Hurricane Planning Commission Meeting Agenda

February 12, 2026
6:00 PM

Agenda Date:	02/12/2026 - Planning Commission
Application Number:	GPA26-01
Action Type:	Legislative
Applicant:	Adam Nielson
Agent:	Karl Rasmussen
Request:	Request for a General Plan Amendment from Single Family to Multifamily.
Location:	1015 N 200 W
Zoning:	R1-10
General Plan Map:	Single Family
Recommendation:	Deny
Report Prepared by:	Fred Resch III

Agenda Date:	02/12/2026
Application Number:	ZC26-01
Type of Application:	Zone Change Application
Action Type:	Legislative
Applicant:	Adam Nielson
Agent:	Karl Rasmussen
Request:	A Zone Change from R1-10 to RM-1
Location:	1015 N 200 W
Zoning:	R1-10
General Plan Map:	Single Family
Recommendation:	Deny
Report prepared by:	Fred Resch III

PREL. PLAT- OVERALL SITE PLAN FOR:
GATEWAY AT SAND HOLLOW RESORT

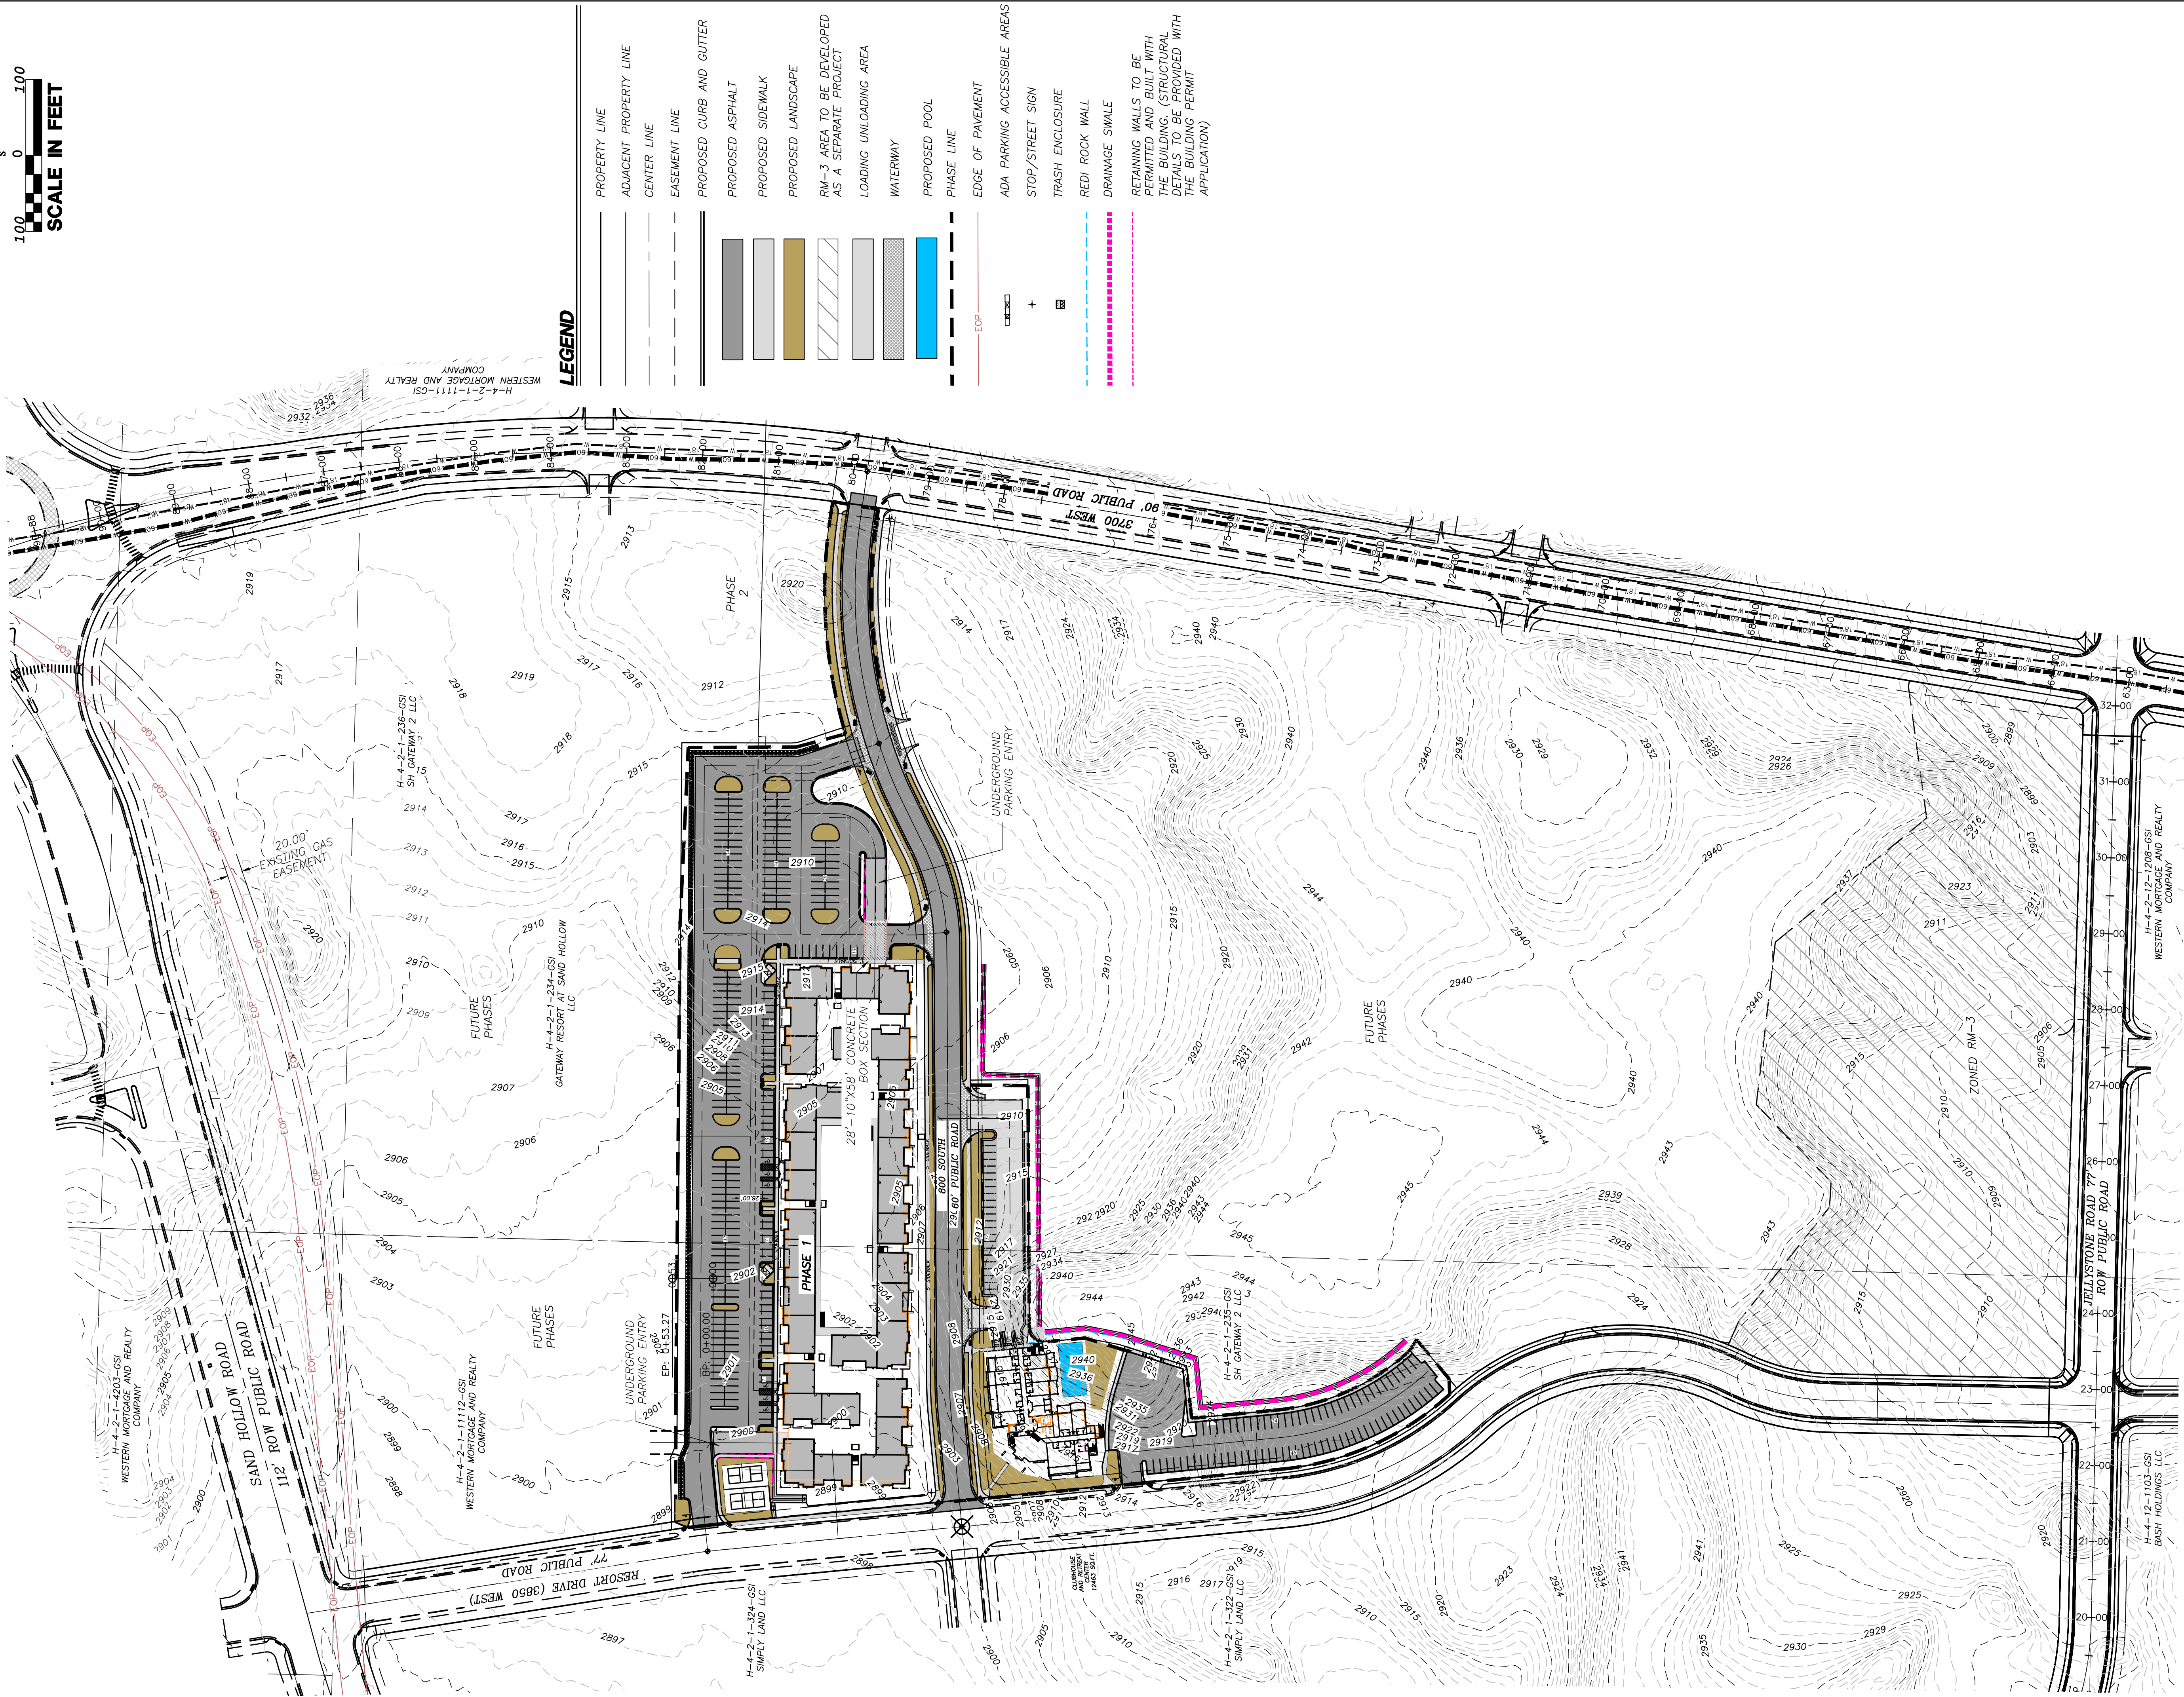
1. **Public Works:** [No comments received.]
2. **Power:** Dixie Power area.
3. **Sewer:** Approved.
4. **Street:** Approved.
5. **Water:** Approved.
6. **Engineering:**
7. **Fire:** Utility plan must be approved.
8. **Cable:** Approved.
9. **Gas:** Approved.
10. **Water Conservancy:** Washington County Water Conservancy District hereby acknowledges that based on the information provided, the proposed plans adequately mitigate interference with district facilities and property interests. The District reserves the right to rescind this acknowledgement if additional information becomes available. The district has not determined whether water will be available for this development and does not hereby make any guarantee of water availability. In addition, the development must conform with applicable district requirements, including but not limited to payment of fees.

2. **Parking:** The applicant is proposing 525 parking spaces for this phase, with 231 stalls being in an underground parking garage below the building. The parking standard for resorts is one space per bedroom (Hurricane City Code (HCC) 10-26-6(E)) while the applicant has not proposed specific floorplans to verify the number of bedrooms this is almost certainly sufficient. Some parking will need to be set aside for the clubhouse and pool. In addition, 19 RV and trailer parking spaces are required. The city has accepted “pull through” spaces to count towards this standard. The applicant will need to provide a more detailed parking breakdown for the final site plan.

3. **Amenities:** Per HCC 10-26-4, one clubhouse and one pool are required with this phase and must be constructed with the first phase. The plan indicates that three pools and the clubhouse will be constructed with this phase, thus meeting the requirement.

6. **Water use:** To assist the Washington County Water Conservancy District (WCWCD) as the city’s wholesale water provider under the 2006 Regional Water Supply Agreement, Hurricane City and other cities report monthly the number of final platted lots, preliminary platted lots, lots subject to development agreements, and lots within PID taxing areas. These numbers help the WCWCD plan for future water needs and inform the WCWCD’s 20-year plan to supply water to the growing County. As part of the Gateway to Sand Hollow Public Infrastructure District this development’s 96 units have already been reported to WCWCD.

Recommendation: Staff recommends the Planning Commission review this application based on standards with Hurricane City Code. Staff would recommend approval subject to staff and JUC comments.
